Product / Process Change Notification (PCN)					
<input checked="" type="checkbox"/> Major Change <input type="checkbox"/> Minor Change					
PCN Number: PCN_UtLAN_20240807 Affected Series: PCN_UtLAN_20240807 Affected Order Codes: 749014011, 749014012, 7490140110, 7490140112, 749024010, 749024012 PCN Date: 2024-05-07 (YYYY-MM-DD) Effective Date: 2024-08-07 (YYYY-MM-DD)	Change Category: <input checked="" type="checkbox"/> Equipment/Location <input checked="" type="checkbox"/> General Data <input type="checkbox"/> Material <input checked="" type="checkbox"/> Process <input checked="" type="checkbox"/> Product Design <input checked="" type="checkbox"/> Shipping/Packaging <input checked="" type="checkbox"/> Supplier <input type="checkbox"/> Software				
Contact: Product Management Phone: +49 (0) 7942 - 945 5001 Fax: +49 (0) 7942 - 945 5179 E-Mail: pcn.eisos@we-online.com	Datasheet Change: <input checked="" type="checkbox"/> Yes <input type="checkbox"/> No Attachment: <input type="checkbox"/> Yes <input checked="" type="checkbox"/> No				
Description of Change: Due to internal standardisation, Würth Elektronik eiSos will move the production to new production line. The packaging as well a

2. Packaging change:

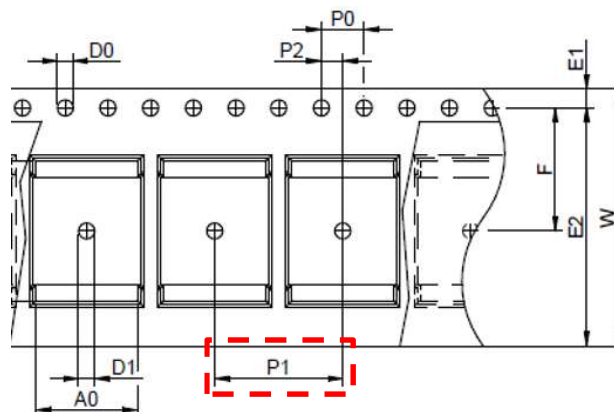
Affected order codes: 749014011, 7490140110, 7490140112, 749014012, 749024010

Before Change	After Change
SPQ:	250 pcs	200 pcs
Carton Quantity:	750 pcs	1200 pcs
Carton Length:	365 mm	370 mm
Carton Width:	342 mm	400 mm
Carton Depth:	230 mm	370 mm

5. Datasheet correction

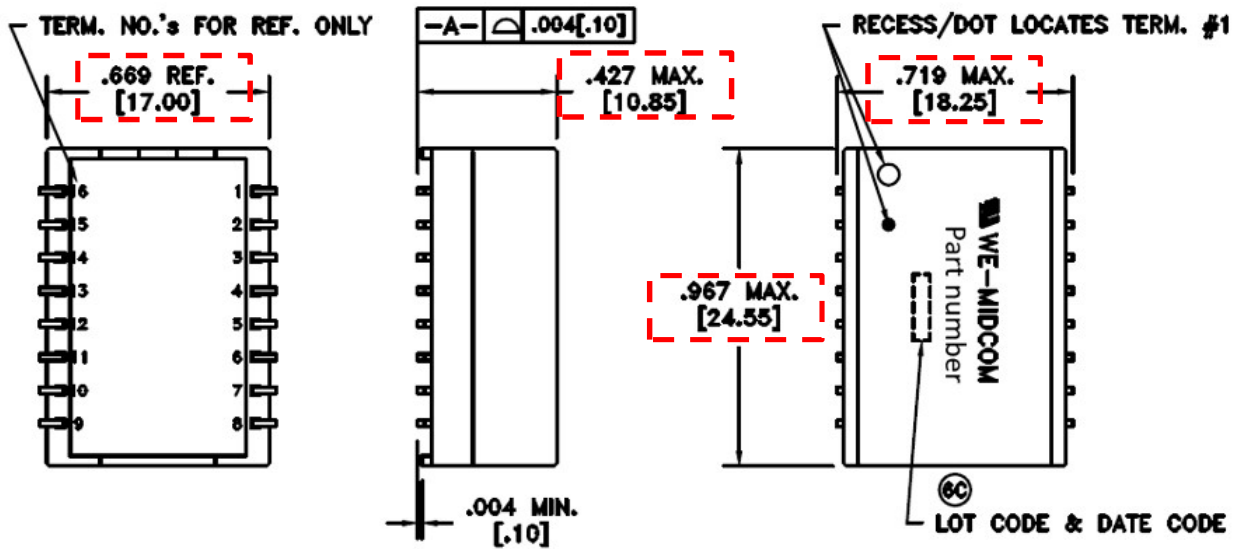
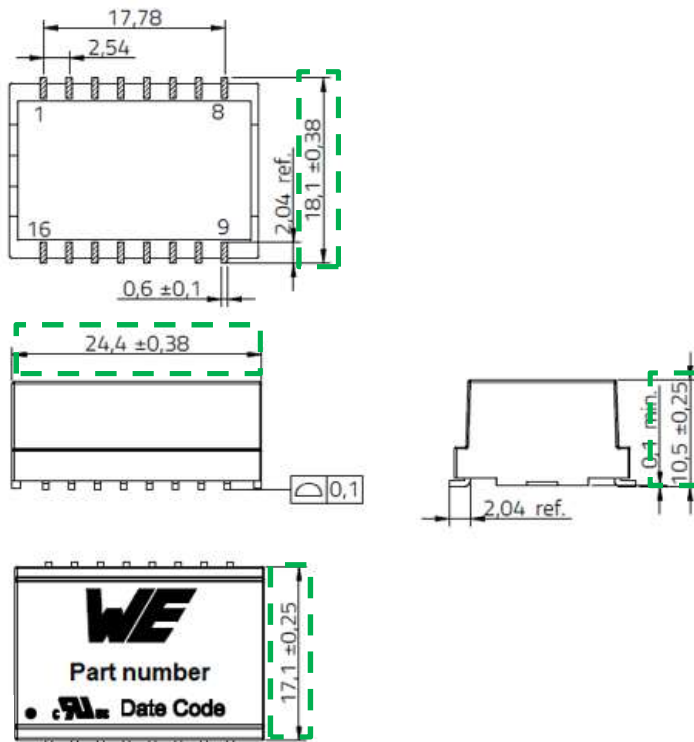
Affected order codes: 749014011, 7490140110, 7490140112, 749014012, 749024010

Before change:

After change:

5. Datasheet correction

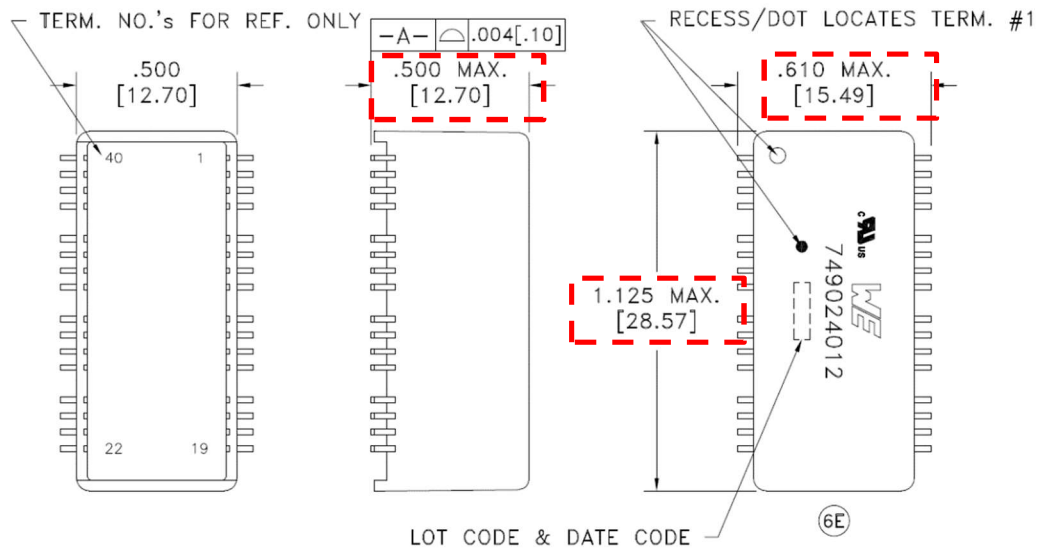
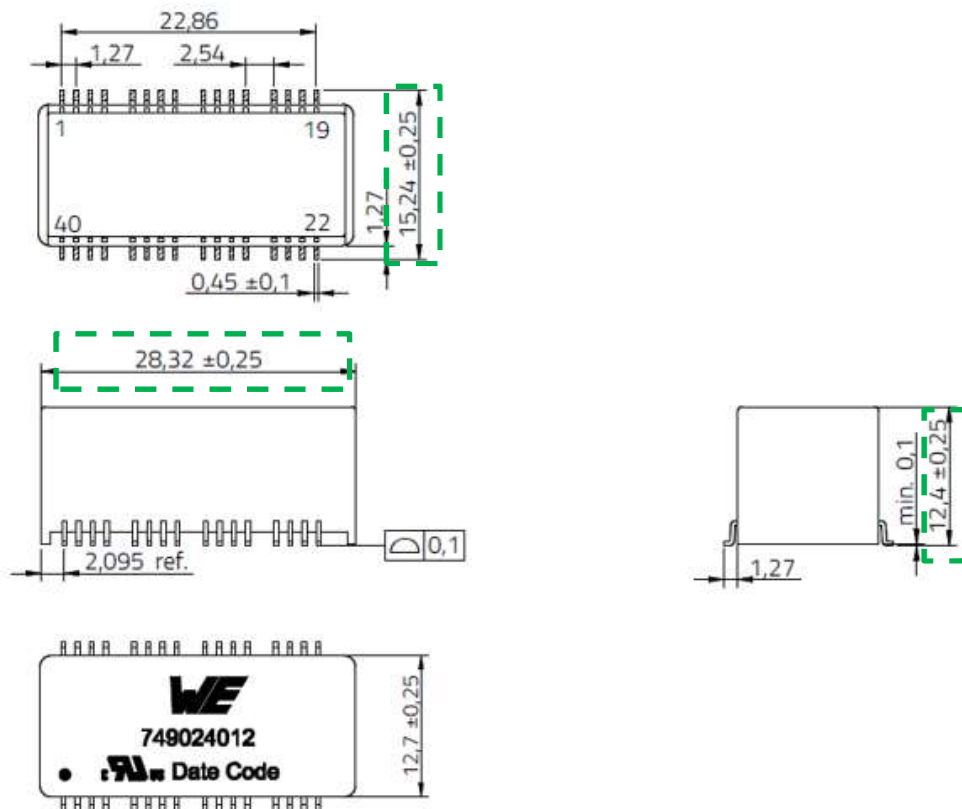
Affected order code: 749024012

Before change:

After change
